Access Compliance Report

Public Rights-of-Way

(Curb Ramps)

Intersection ID: 11003	Main Street: CAMP_GREENE_ST	Cross Street: RINGWOOD_ST	Location: SE
ADA ID: 94150A17AD29	Ramp Type: PerpDiag	Initial Pass/Fail: Fail	Overall Compliance: No
Severity Score: 22.5			
Codes/Mitigation Info/Possible Solution		Field Measurements/Component Compliance

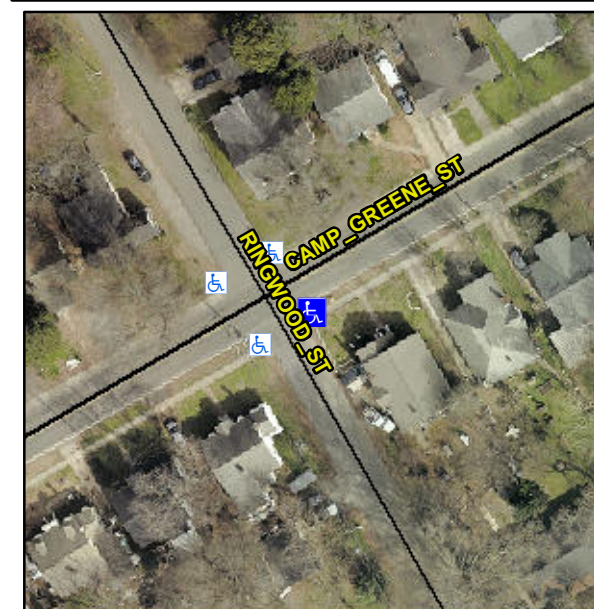
R304.5.1, R304.2.2, R304.5.3

Compliance	Description	Data	Compliance	Description	Data
N/A	Ramp Length (in)	56.0	No	Ramp Slope (%)	9.2
No	Ramp Width (in)	47.5	No	Ramp XSlope (%)	2.3
N/A	Flare Type LT	N/A	N/A	Flare Type RT	N/A
N/A	Flare Slope LT (%)	N/A	N/A	Flare Slope RT (%)	N/A
N/A	Flare Traversable LT?	N/A	N/A	Flare Traversable RT?	N/A
N/A	Landing Length (in)	N/A	N/A	DWS Provided?	N/A
N/A	Landing Width (in)	N/A	N/A	DWS Contrast?	N/A
N/A	Landing Slope (%)	N/A	N/A	DWS Length (in)	N/A
N/A	Landing X Slope (%)	N/A	N/A	DWS Full Width?	N/A
N/A	Landing Curb? (Y/N)	N/A	N/A	DWS Offset (in)	N/A
N/A	Shared Landing?	N/A			
N/A	Gutter Ponding?	N/A	N/A	Gutter Slope (%)	N/A
N/A	Gutter Lip Ht (in)	0.5	N/A	Gutter X Slope (%)	N/A
N/A	Painted X Walk1?	No	N/A	Painted X Walk2?	No
	X Walk 1 Direction	To N		X Walk 2 Direction	To W
N/A	X Walk 1 Width (in)	N/A	N/A	X Walk 2 Width (in)	N/A
	X Walk 1 Slope (%)	2.1		X Walk 2 Slope (%)	0.0
	X Walk 1 X Slope (%)	3.0		X Walk 2 X Slope (%)	1.9

N/A	Ramp inside XWalk1?	N/A	N/A	Ramp inside XWalk2?	N/A
	Road Slope (%)	5.4	N/A	Clear Space?	N/A
	Road X Slope (%)	7.0	N/A	Clear Space to XWalk (in)	N/A
N/A	Any Obstructions?	N/A	N/A	Storm Grate/Utility Hazard?	N/A
	Obstruction Type			Storm Grate/Utility Type	
		N/A			N/A
			Yes	Surface Condition? (G/P)	Good

Remove & Replace Curb Ramp With Two New Directional Ramps or Equivalent.
